Product Change Notice (PCN)

PCN Number: **PCN-0456185R-01**

Product(s) Affected: **SJ-435107 & SJ-435107RS**

PREVIOUS SAME SKY DETAIL / IMAGE	NEW SAME SKY DETAIL / IMAGE

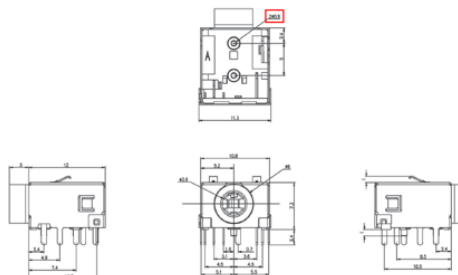
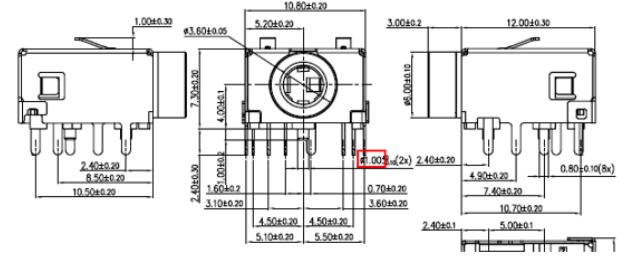
Description of Change: *New Factory Location. Product re-engineered for improved manufacturability and production yield. See image below for reference and check the Same Sky website for updated drawing after 10/20/2024. Cosmetic differences may be visible but will not affect the form fit and function of the product.*

PREVIOUS SAME SKY DETAIL / IMAGE			NEW SAME SKY DETAIL / IMAGE		
DESCRIPTION	MATERIAL	PLATING/COLOR	DESCRIPTION	MATERIAL	PLATING/COLOR
terminal (1-6)	copper alloy	tin	terminal (1-6)	copper alloy	tin
shield	copper alloy	nickel	shield	brass	nickel
bushing	brass	nickel	bushing	brass	nickel
housing	PA66 (UL94V-0)	black	housing	PA66 (UL94V-0)	black
